### WASHINGTON COUNTY PLANNING COMMISSION

July 19, 2021, 7:00 PM

**Northpoint Dickinson**  
**Planning Commission Hearing**  
**Presented by: Ashley R. Holloway**  
**7/19/2021**

PRELIMINARY CONSULTATION PLAN  
FOR  
NORTHPOINT DICKINSON

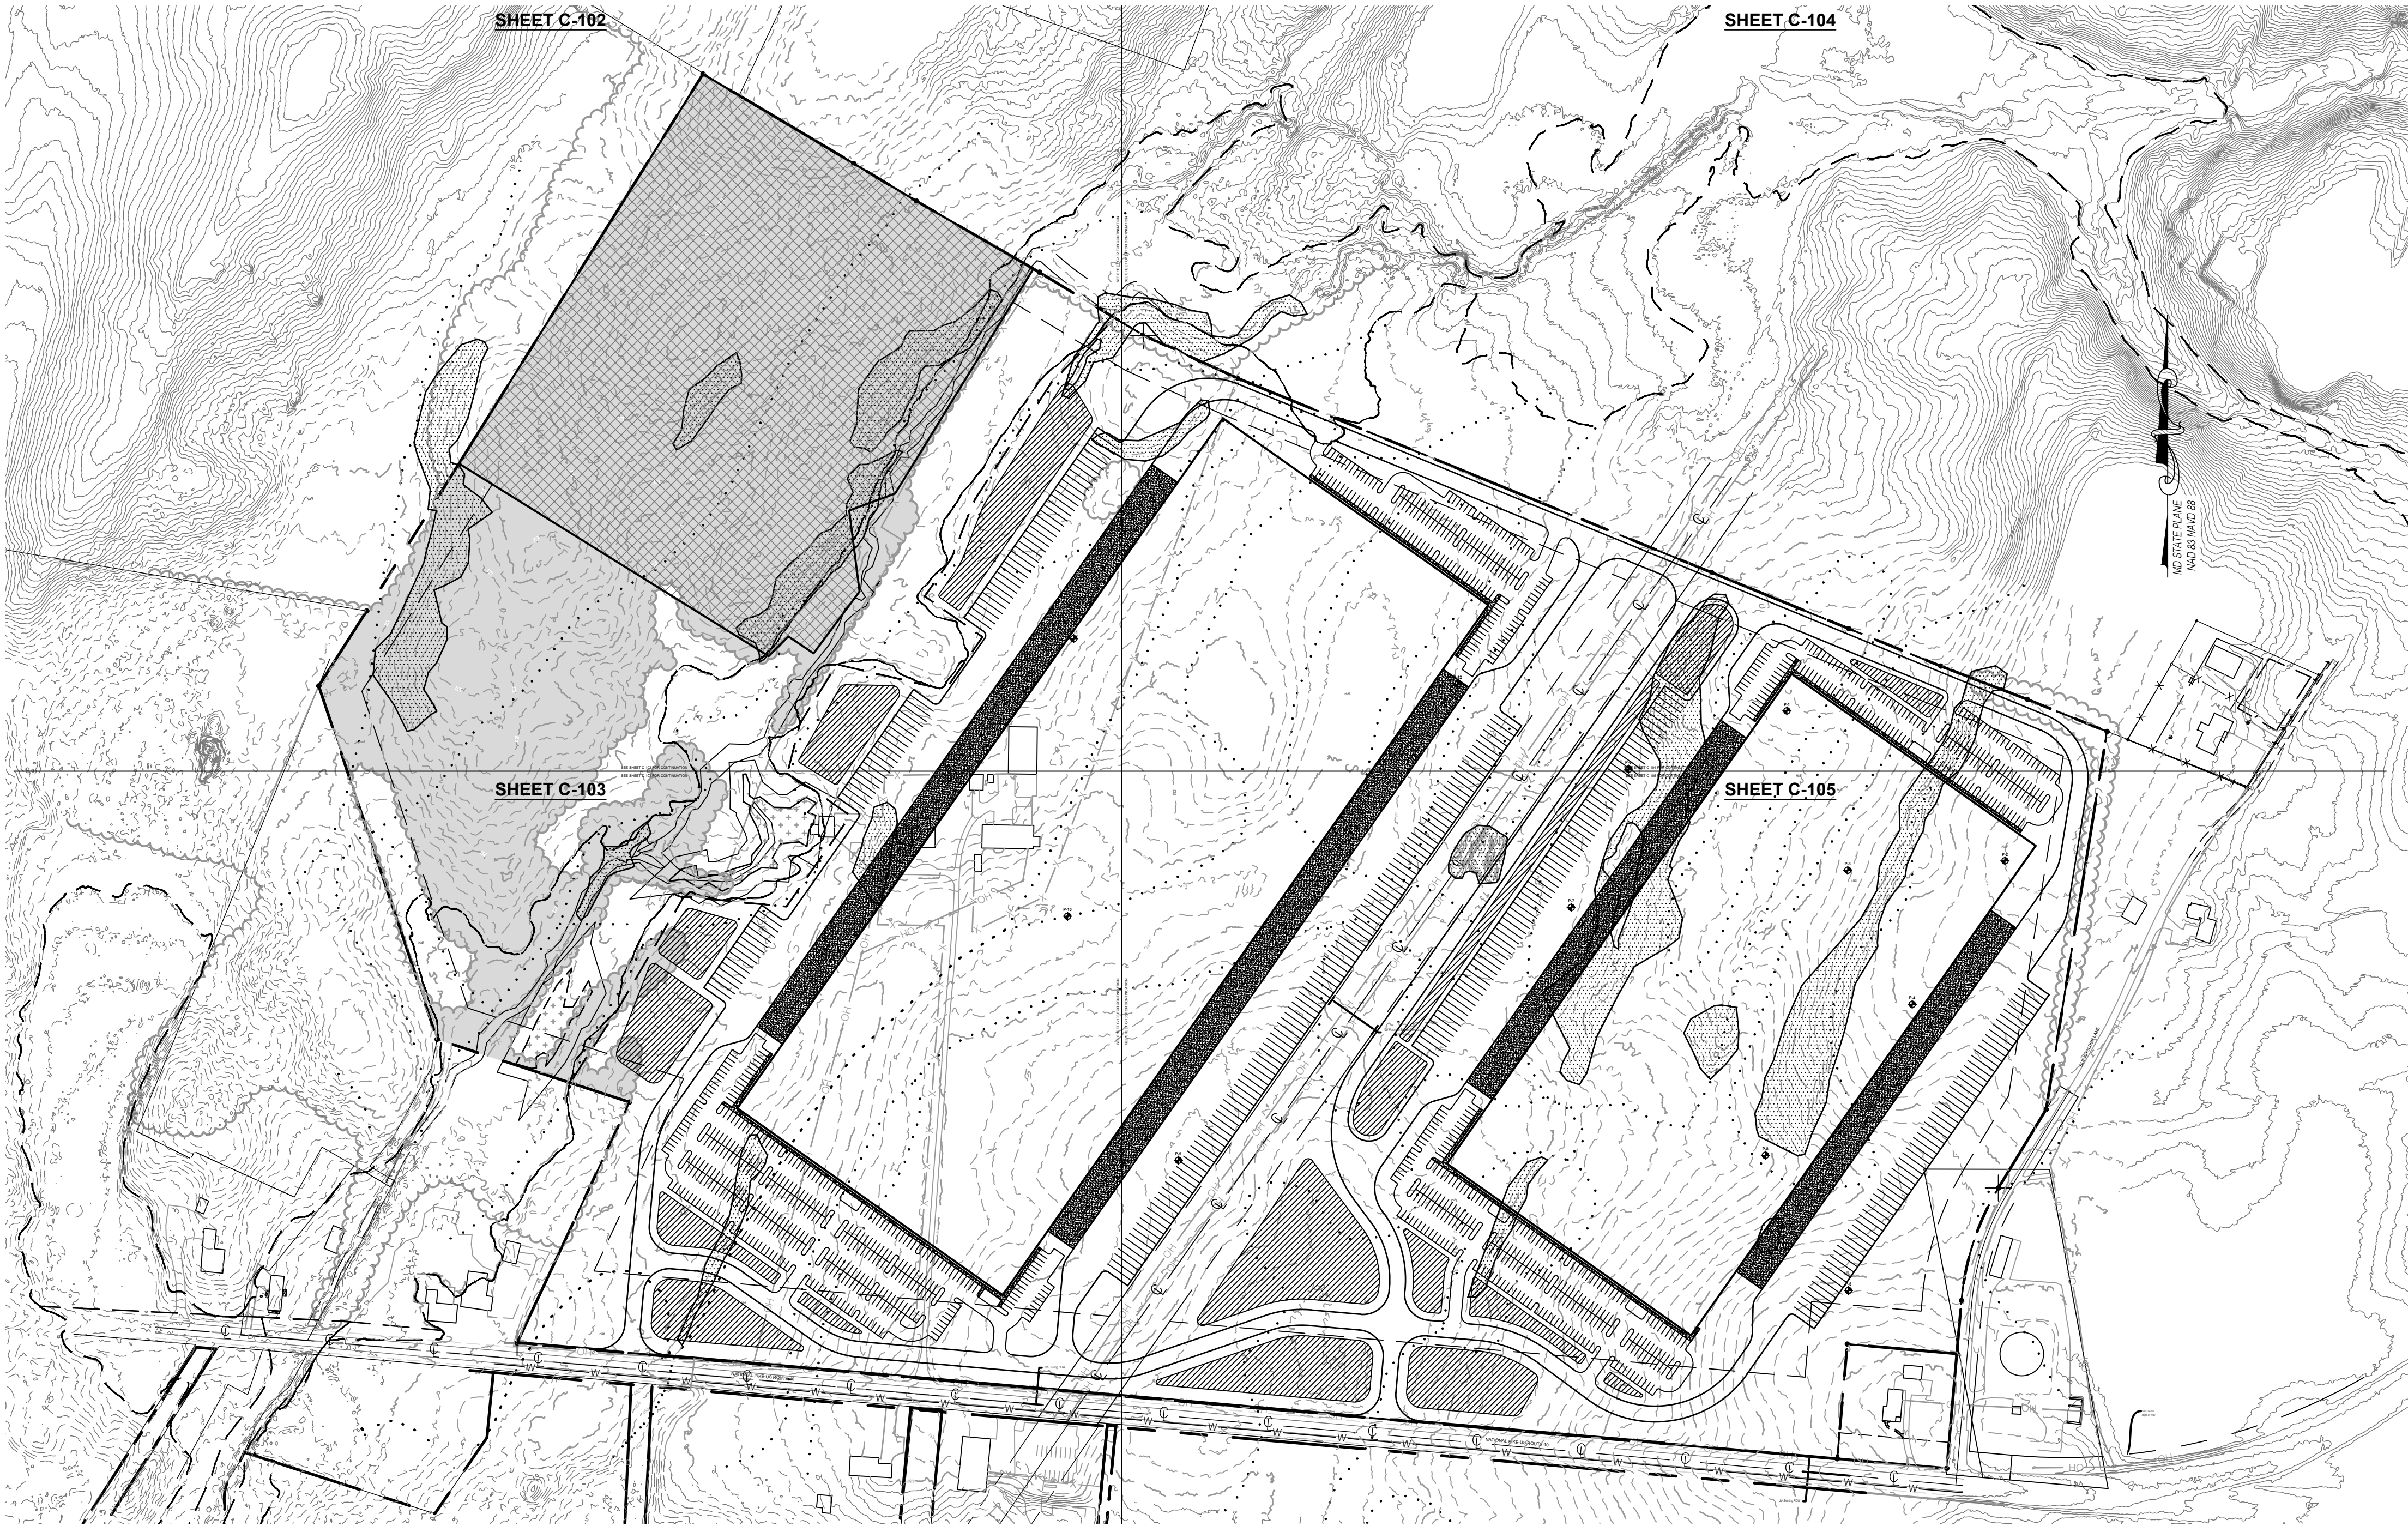
Mr. Allen wrote, "The proposed development will almost certainly necessitate the removal of many specimen trees. This will require the approval of a variance by the Washington County Planning Commission at their regular monthly meeting. Every effort should be made to preserve as many of these trees as possible in the design of the development. Specimen Trees #11 and 12, in particular, should be retained and protected in the design and construction of the SWM facility shown on sheet 3. It is unclear if its current location will impact those specimen trees."

"1. Provide a Topography Map with the drainage areas delineated for all stream segments on-site. As presented, a soils map was provided with a portion of the stream segments addressed; a Topography Map is required. Further, there are 5 stream segments to be addressed; only 3 have been partially addressed. If any of the streams require buffers, based upon soil type and/or drainage area, etc., show and address within the design accordingly. Additionally, the Stream Buffer Criteria applies to any stream associated with wetlands and their associated State mandated buffers.

2. I assume the proposed grading impact to qualified forest will be addressed; please clarify.

3. Be sure to address Steep Slope designations with the Soil Erosion and Sediment Control Plan design.

4. Be sure to address sinkhole remediation as a first order of business within the Soil Erosion and Sediment Control Plan, as well as consider in the design of stormwater conveyances and structures.

8. The Geotechnical Report recommends a more detailed exploration be undertaken in conjunction with the forthcoming design; please provide the report accordingly.

1. Provide a Topography Map with the drainage areas delineated for all stream segments on-site. As presented, a soils map was provided with a portion of the stream segments addressed; a Topography Map is required. Further, there are 5 stream segments to be addressed; only 3 have been partially addressed. If any of the streams require buffers, based upon soil type and/or drainage area, etc., show and address within the design accordingly. Additionally, the Stream Buffer Criteria applies to any stream associated with wetlands and their associated State mandated buffers.

2. I assume the proposed grading impact to qualified forest will be addressed; please clarify.
3. Be sure to address Steep Slope designations with the Soil Erosion and Sediment Control Plan design.

4. Be sure to address sinkhole remediation as a first order of business within the Soil Erosion and Sediment Control Plan, as well as consider in the design of stormwater conveyances and structures.

6. With cuts proposed at 30-40 feet, please evaluate all soils for elevated ground water levels, etc. and address accordingly within the forthcoming design.
7. Include Rock Encountered Notes based upon depths determined during the borings.
8. The Geotechnical Report recommends a more detailed exploration be undertaken in conjunction with the forthcoming design; please provide the report accordingly.
9. We strongly recommend addressing stormwater structure hazard class designations early in the design process.
10. Please keep in mind, the above comments may alter the design; please evaluate all and address accordingly.
11. The Concept/Preliminary Consultation Plan is approved; address all comments with the forthcoming design plans.
